DA2023/832

OBJECTIONS TO DA AMENDED 12/04/24

FROM Robert and Susan Story

2.17 Buffer Distances & Available Land Area

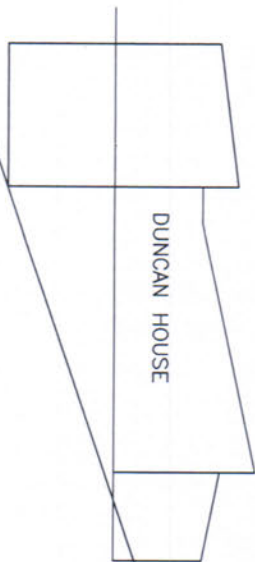
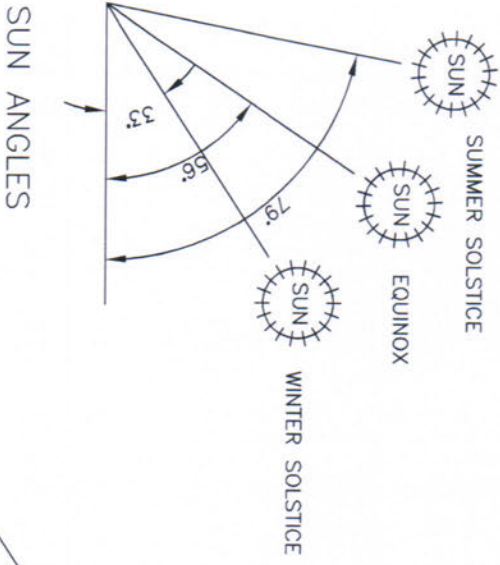
- 1) Boundaries to Lot 3 and Lot 6 have been moved to the correct position.
- 2) Distances to boundary change from 11 meters to 6.2 meters on 2.17. Buffer Distance and Available Land Area.

- 1) Information is required to accurately locate the house in relationship to Lot 3 and Lot 6.
- 2) The EMA is in an unacceptable position and should be moved the northwestern side of the site.
- 3) Being a pump system, it can be located anywhere on the large site and can be installed 20 meters from Lot 3 boundary.
- 4) The present EMA is located 5 meters on the uphill side of boundary to Lot 3. The minimum distance for this as shown on Boradcrest's 2.17 is 12 meters and is still below the 6 meters required for a level site.
